# **PRODUCT CHANGE NOTICE**

**Alternate Manufacturing Site  
for Assembly of the Listed  
Intersil SOT23 Packaged  
Products**

**Refer to:  
PCN13022**

**Date: March 01, 2013**

# PCN13022 – Current POD SOT23 5L

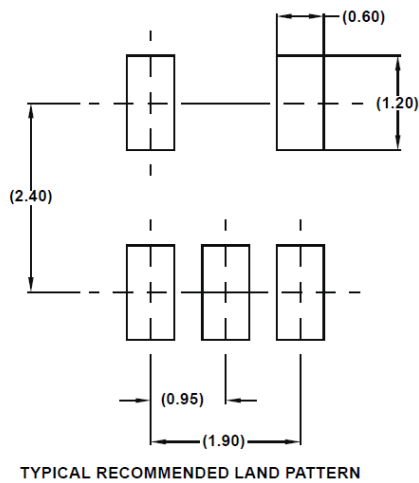
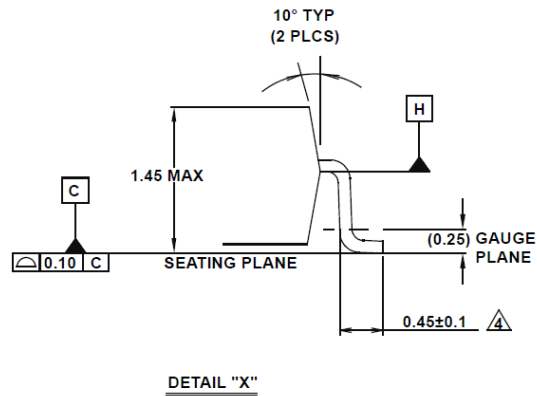
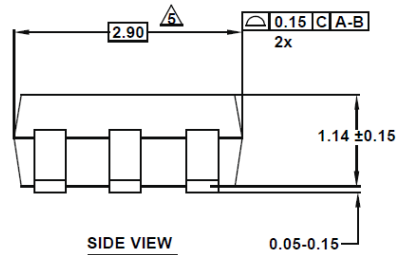
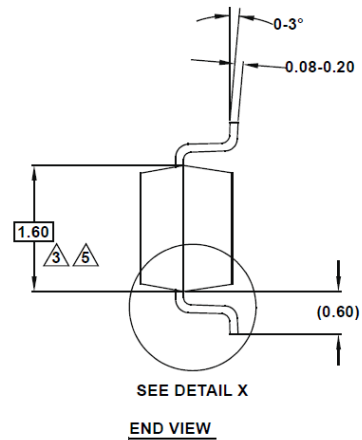
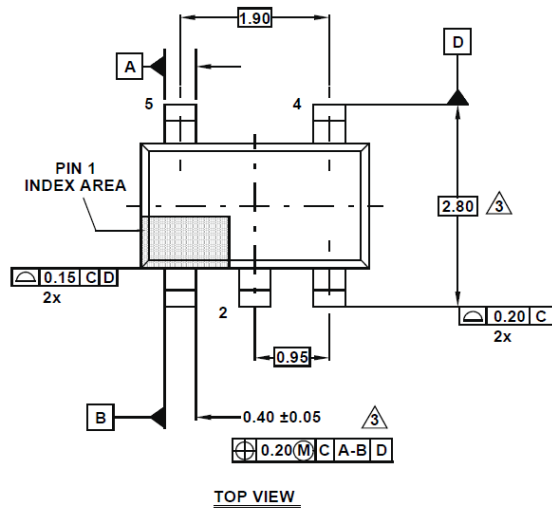
The Carsem (CAM) facility is ISO9001:2008, ISO/TS16949:2009 and ISO14001:2004 certified. The CAM facility is qualified as a supplier to Intersil for performing assembly of packaged products, including the SOT23 package style. There will be no change in the die attach, bond wire (material or diameter), frame material, or moisture sensitivity level (MSL). The packaged devices will require minor dimension changes to the package outline drawings (POD). However, there is no change in the recommended PCB land dimensions. The affected PODs and a summary containing a list of products along with the current and new PODs are included for reference.
